SUBJECT: HOLTEC INTERNATIONAL'S APPLICATION FOR SPECIFIC INDEPENDENT
SPENT FUEL STORAGE INSTALLATION LICENSE FOR THE HI-STORE
CONSOLIDATED INTERIM STORAGE FACILITY FOR SPENT NUCLEAR
FUEL – SECOND REQUEST FOR ADDITIONAL INFORMATION

Second Request for Additional Information

Application for specific independent spent fuel storage installation license for the HI-STORE Consolidated Interim Storage (CIS) Facility in Lea County, New Mexico

RAI 2-20-S: Provide an estimate of the likelihood that flooding may occur from a 100-year storm event as a result of damage to the hydraulic structure near Laguna Gatuna.

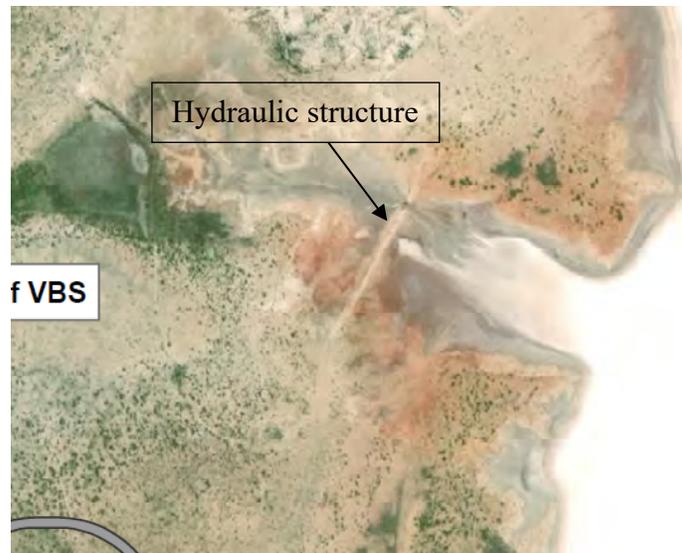
In its response to RAI 2-20, the applicant provided a PMP/PMF study (GEI, 2019), which assumes Laguna Gatuna in 'extreme full' condition, with water inundating the hydraulic structure. The effect of the hydraulic structure on flooding is thus accounted for. However, in the 100-yr storm event, where the Laguna was assumed to be filled with 5 feet deep of water,

runoff into the wash and the hydraulic structure (looking like an earthen dam with an area that has been broken – see picture taken from the GEI report, Fig. 6) may create back water effect, which in turn may cause flooding around the northeastern corner of the proposed CISF. Provide calculations to estimate the likelihood that flooding may occur and, if so, at what depth under this scenario.

Alternatively, most of the water in Laguna Gatuna will be stored east of this structure in a sub-PMP storm event. Provide additional analyses to determine the potential impact of the structure's partial or complete collapse (e.g., the potential for flooding to the wash northeast of the proposed CISF), particularly under sub-PMP weather conditions.
